Re: Response to Submissions (RtS) - SSD- 36138263
Augusta Street Warehouse and Distribution Centre
Augusta Street, Blacktown, NSW

In response to the letter from Blacktown City Council dated 17 June 2024 referenced MC-23-00005, we provide the following responses to the Civil Engineering and Drainage matters.

DRAWING TITLE
FINISHED LEVELS PLAN WAREHOUSE 3

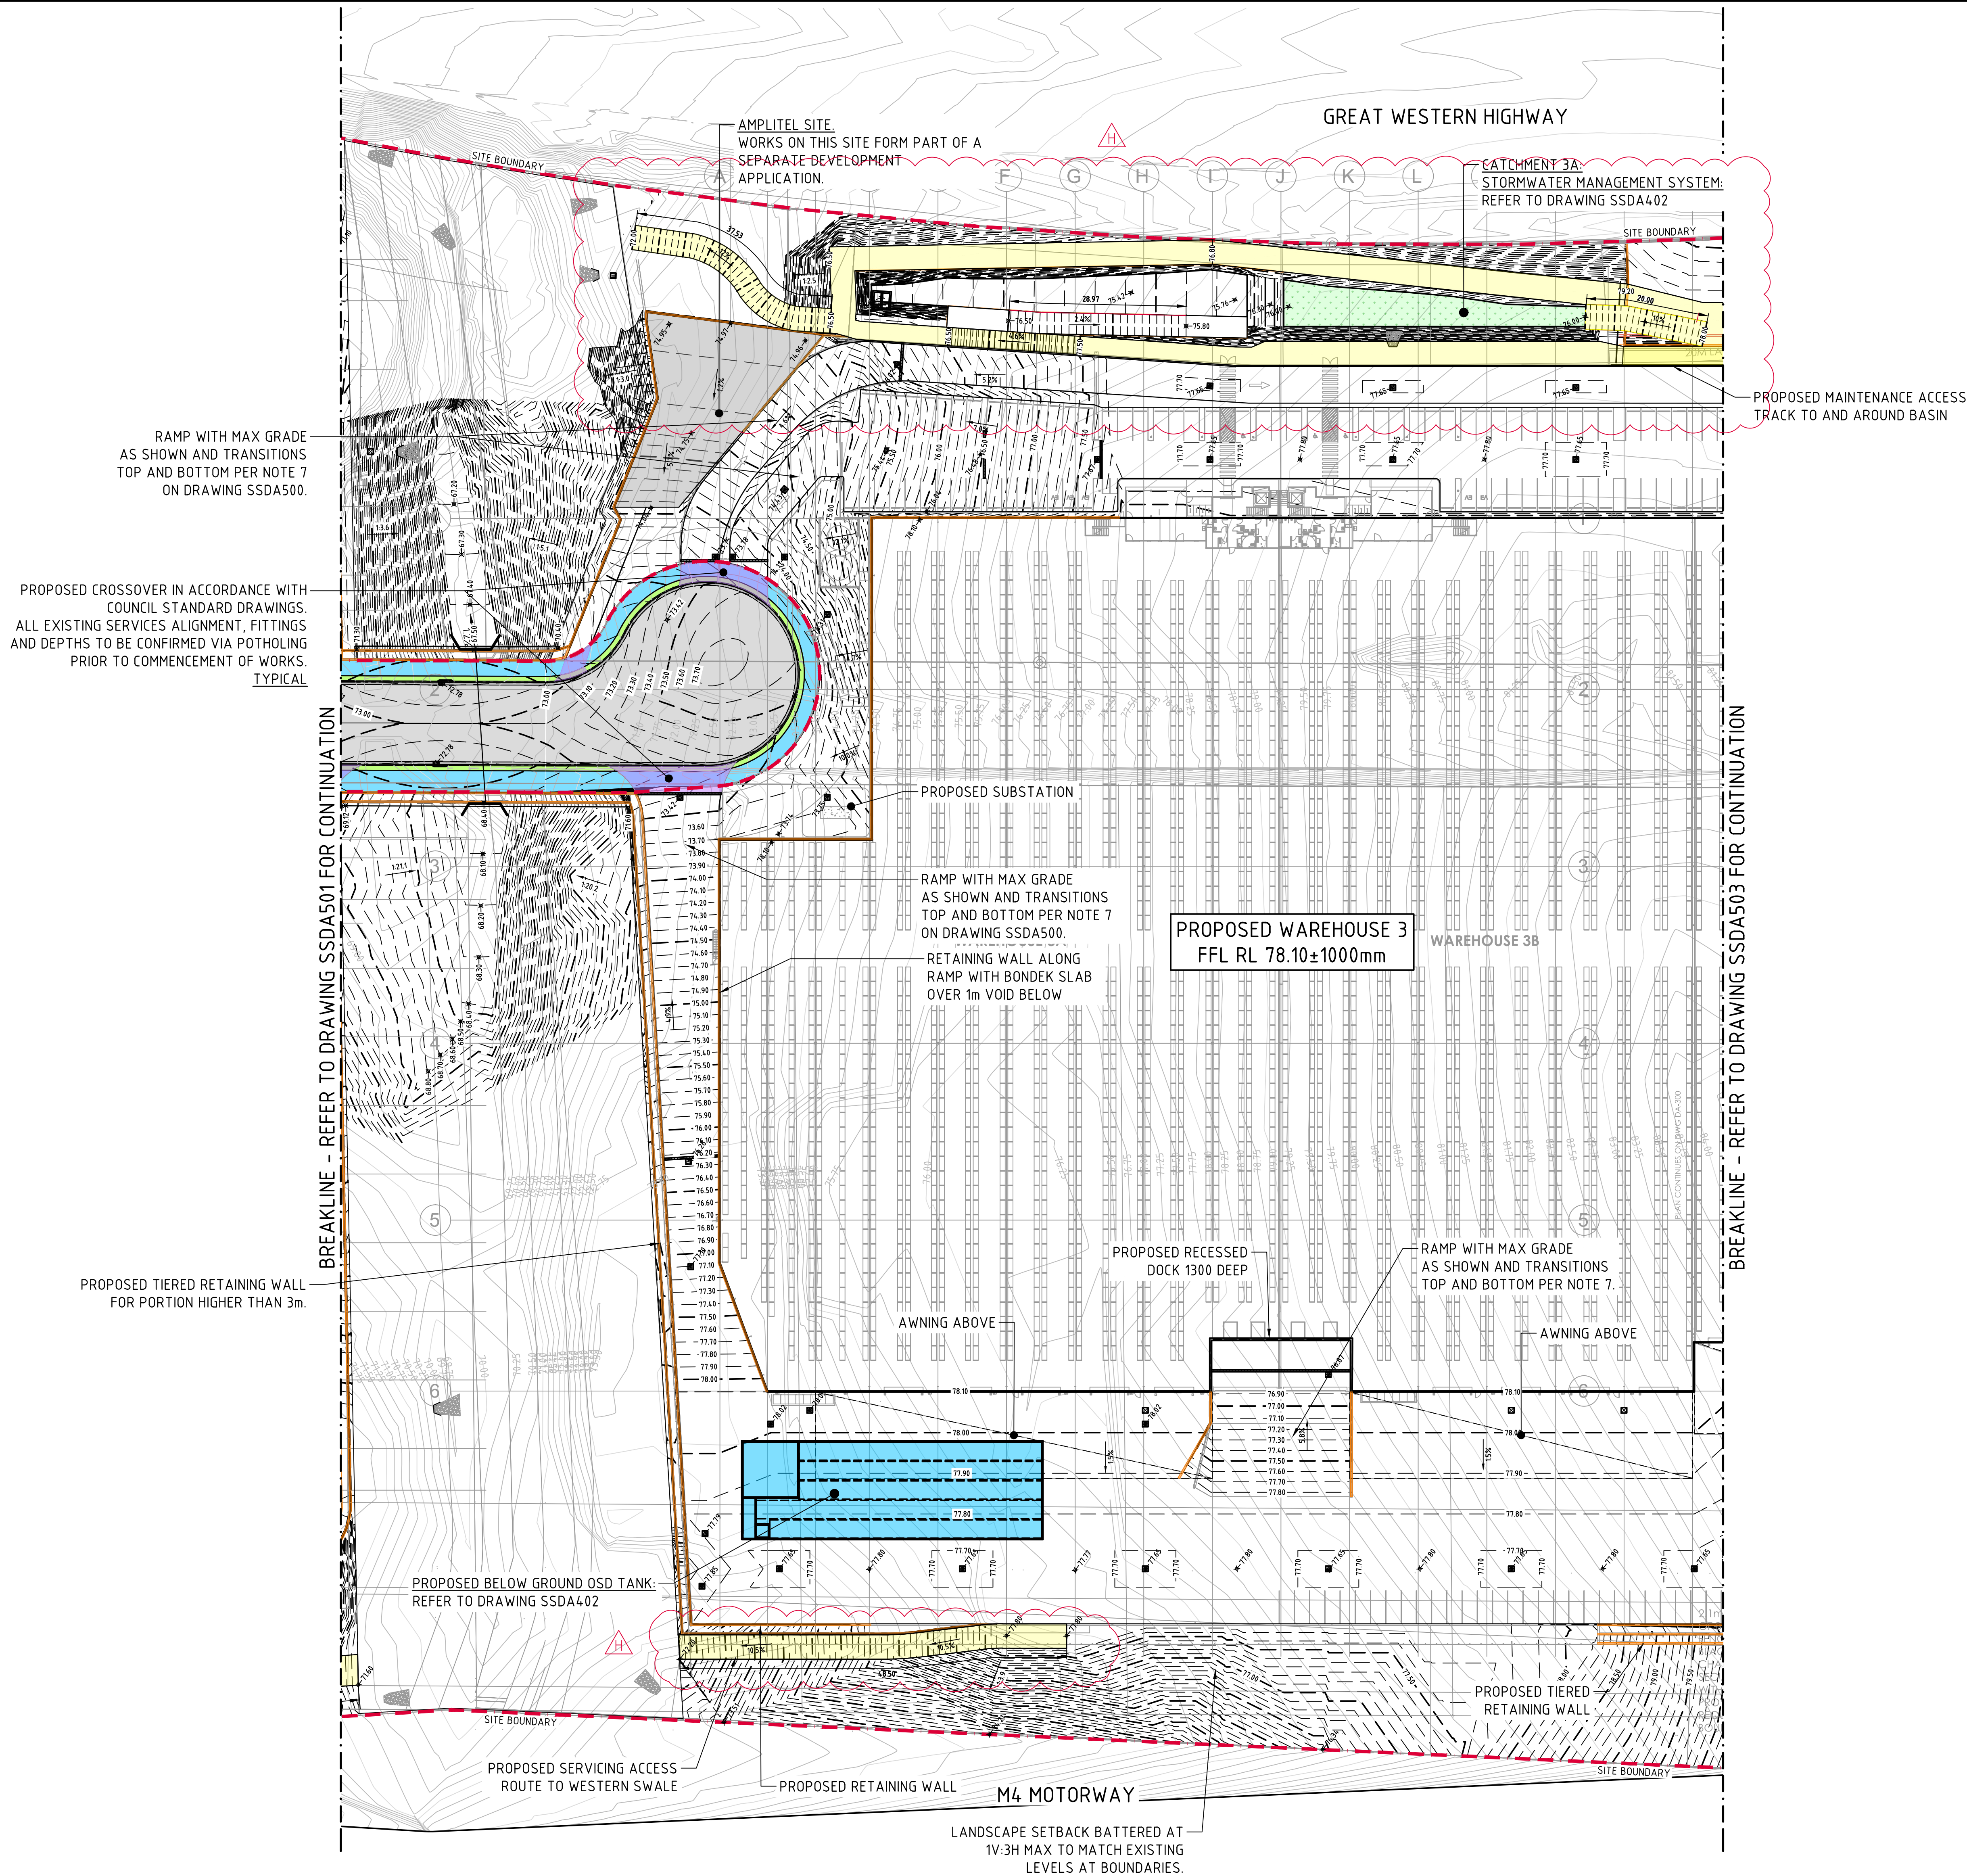
4	The longitude section of the access track shall be provided to prove the gradient is not more the 10%. Also, the access track must be at least 4 meter wide.	We note the request to provide longitudinal sections of the access tracks across the site. We have provided the necessary (requested) information in the updated drawing package in the format discussed below. The drawing package has been updated to indicate the conceptual finished surface levels at both the top and bottom of each ramp/track as well as a dimension indicating the concept length of the track. Additionally, the maximum slope of each access track is shown along the tracks (see drawings C501, C502, C503, and C504). This confirms that all access tracks will comply with the maximum gradient requirement of 10%. Extraction of long sections along these access tracks will require a certain level of 3D design deemed to be a detail design item. Please refer to the example below for the format in which these ramp grades are indicated.

All access tracks have been revised to be 4m wide.

Refer to Enclosure 2 for drawings C501 to C504 with updated maintenance access tracks shown and clouded for ease of reference.
